Revised 10GBASE-T PHY Control with integrated link monitor (version 2)

Gottfried Ungerboeck, Broadcom Corporation

Abstract: This report describes a revised version of PHY Control in which the link-monitor function is part of PHY Control. A small change required in the state diagram of Auto Negotiation is shown in the Appendix. PHY Control differs from PHY Control as described in 10GBASE-10 Draft 2.3 in various ways. (1) InfoFields are reorganized and shortened to 8 octets. The 4-octet payload field thereof contains a state indicator and is state dependent. (2) The MASTER sends invitations to the SLAVE to start SLAVE transmission only at specified times rather than allowing the SLAVE to start transmission at any time during time windows of many PMA training frames. (3) Final transmit-power settings are achieved prior to coefficient exchange. (4) MASTER and SLAVE operations become fully symmetric shortly after the start of SLAVE transmission; each PHY can determine the minimum time spent in a particular state. (5) The link partners are not required to transition into states PMA_Fine_Adj, PCS_Test, PCS_Data nearly synchronously under MASTER control as in Draft 2.3.

Figure 28–16—Arbitration state diagram

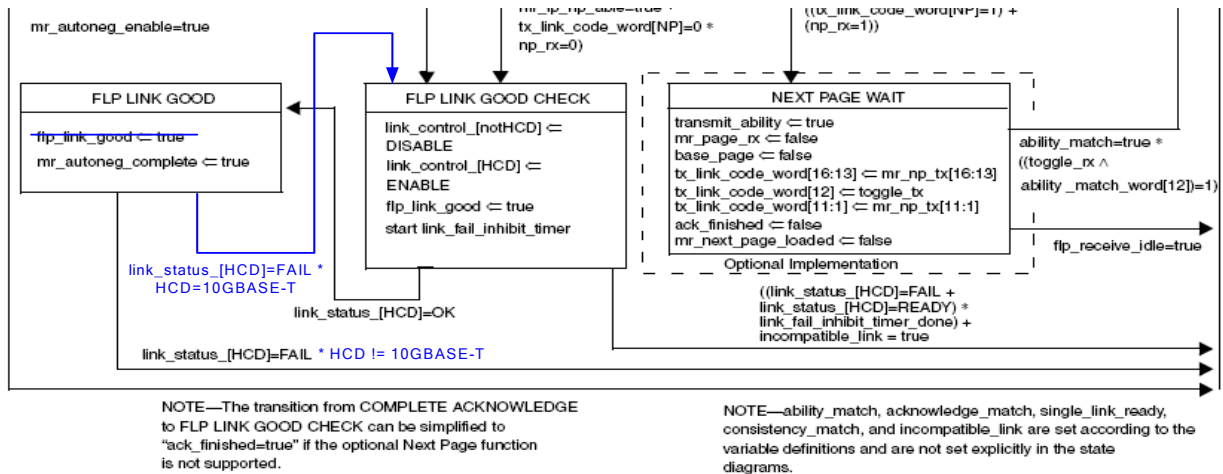
[Restarting link_fail_inhibit_timer in case of PMA retraining requires a small change in the Arbitration state diagram of Clause 28, Figure 28-16. The change is shown in the Appendix at the end of this document]

Required change in Auto Negotiation
